IEEE802.3bt  
LLDP adhoc

Meeting #4: Wednesday July 5, 2017  
Revision 001

# LLDP concept review as agreed in D2.5 – Updated per the current text Proposal for a change marked in RED. Agreed concept marked in BLUE.

## Annex A: Why we need $Y=A+B$ as currently in the spec? -2

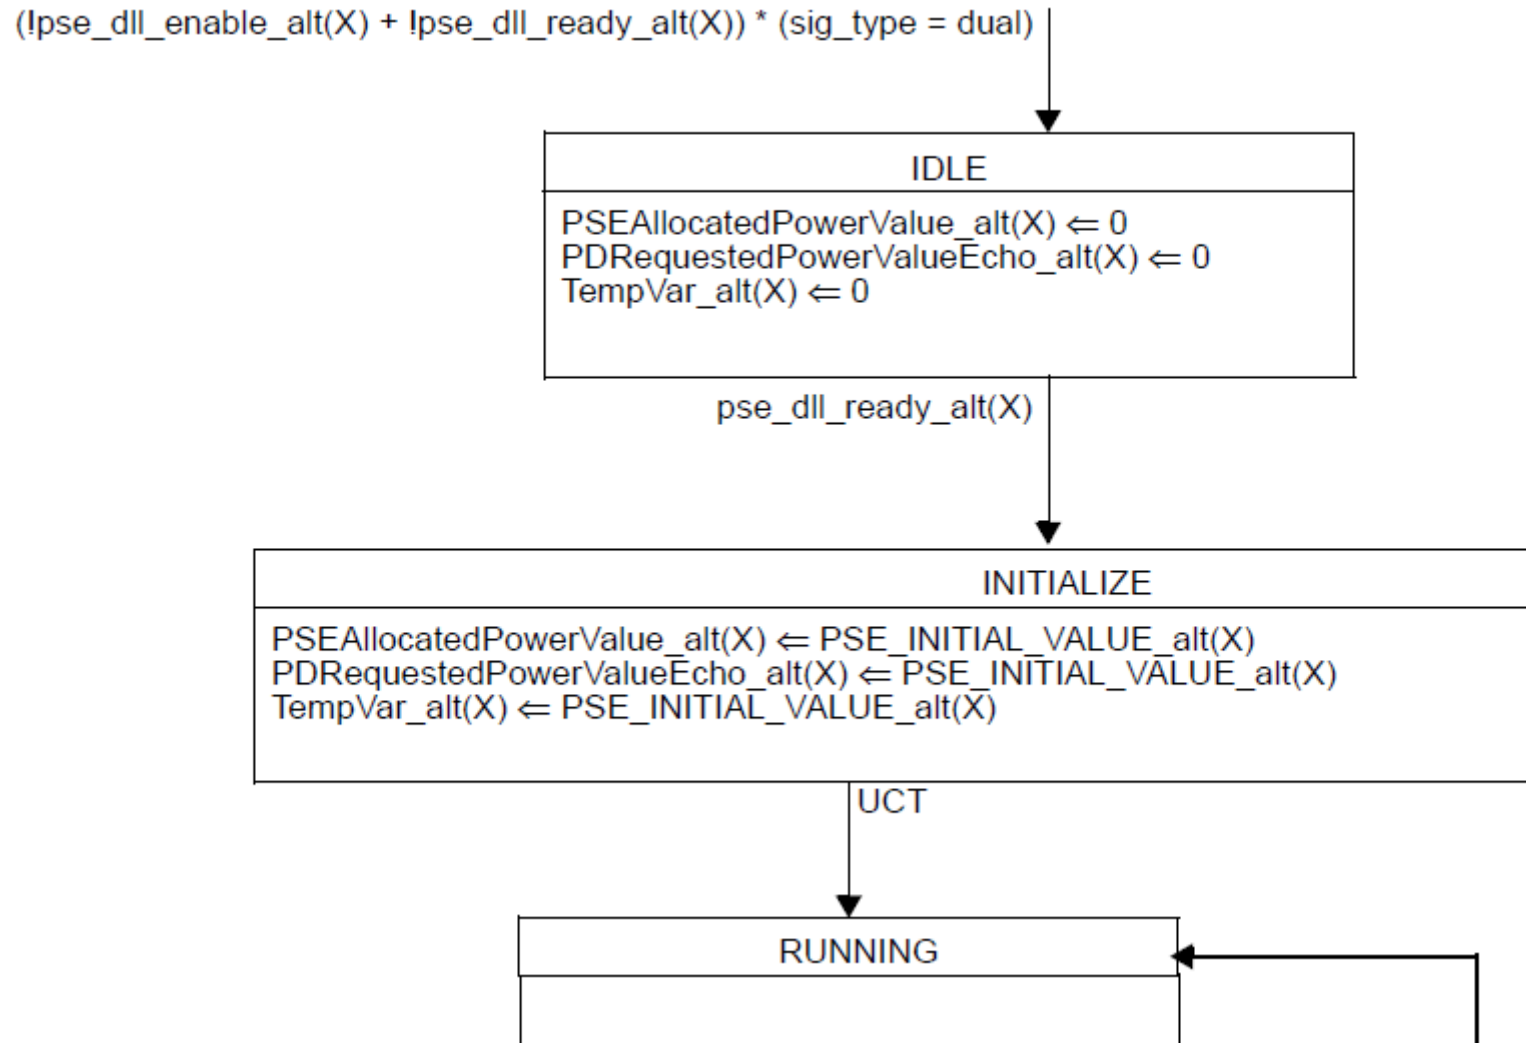
- Argument #3

High level power management care only for the total port power. The power management per pairset is kind of sublayer of the power management system. It is useful to pass the total power through the TLVs field. This is in general how current PSEs systems works.

Other alternative solution to this problem is to use the field “PSE max available power” which should be the total port power. We need to clarify in 79.3.2.6e that this value is applicable for PSE that supports single-signature and dual-signature.

## Annex B: Comment #297 D2.4 (Page 75 line 12 in D2.5) - Figure 145-43

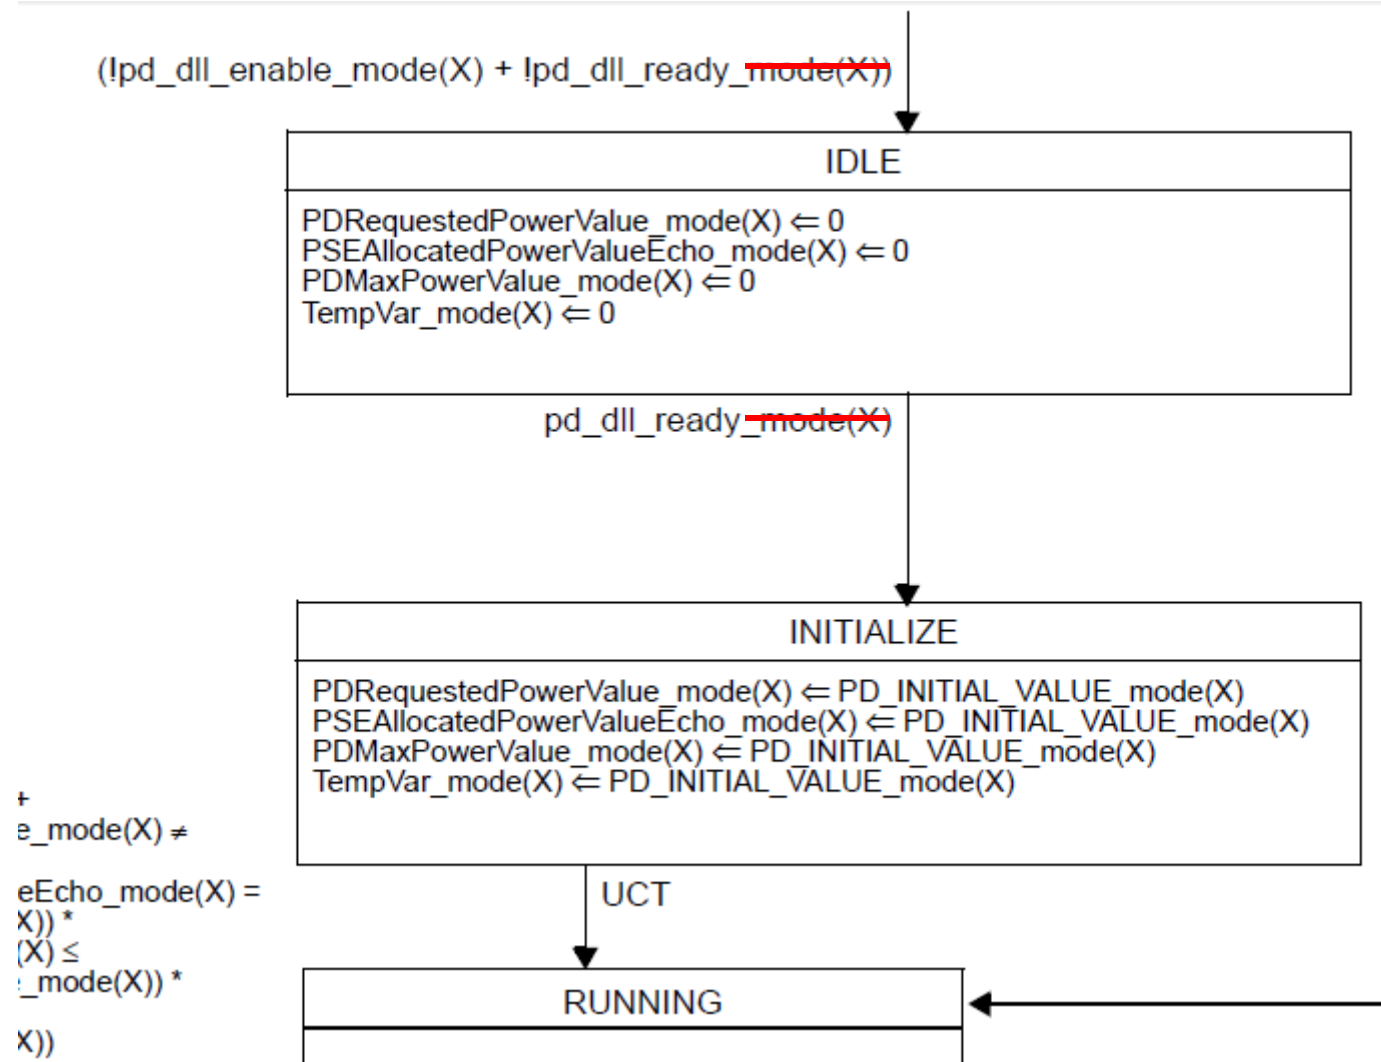
- We have the information of total available power in the field “PSE maximum available power” in 79.3.2.6e. This resolve argument #2 in Annex A.
- To resolve #297, Lennart suggests: In order to request power on the unpowered pairset, see proposed changes in the red text. In addition, the `pd_dll_ready_mode(X)` need to be changed to `pd_dll_ready` to allow progressing to the INITIALIZE state in case PD want power on the unpowered pairset. No changes required in the PSE portion.

- Yair it will work:
- The proposal is:
  - To change from `pd_dll_ready_mode(X)` to `pd_dll_ready` in the PD state machine.
  - To change “if this mode/Alt is inactive, set to value 0” to “if this Alt is inactive, set to value 0” i.e. keep this requirement only to PSE.

- What is this trying to do ? The PD may wish to ask for power on an unpowered Mode...

-----  
Yair: What we are trying to do is:

- In Figure 145-44 and Figure 145-45 power control state diagrams when connected to dual-signature PD, we add in D2.3 an IDLE state in order to resolve non active Alternative(X) or no active mode(X) by setting the relevant variables to zero prior going to INITIALIZE state.
  - Figure 145-45: PSEAllocatedPowerValue\_alt(X), PDRequestedPowerValueEcho\_alt(X) and TempVar\_alt(X)
  - Figure 145-46: PDRequestedPowerValue\_mode(X), PSEAllocatedPowerValueEcho\_mode(X), PDMaxPowerValue\_mode(X) and TempVar\_mode(X)

- Group is OK.

- Lennart response: The proposed response to this comment is to adopt:
  - To change from `pd_dll_ready_mode(X)` to `pd_dll_ready` in the PD state machine.
  - To change “if this mode/Alt is inactive, set to value 0” to “if this Alt is inactive, set to value 0” i.e. keep this requirement only to PSE.
- **Group to discuss.**
- **GROUP OPINION? Group is OK.**
  - The modifications proposed to the state machine in Figure 145-43?
  - To change from `pd_dll_ready_mode(X)` to `pd_dll_ready` in the PD state machine.
  - To change “if this mode/Alt is inactive, set to value 0” to “if this Alt is inactive, set to value 0” i.e. keep this requirement only to PSE.
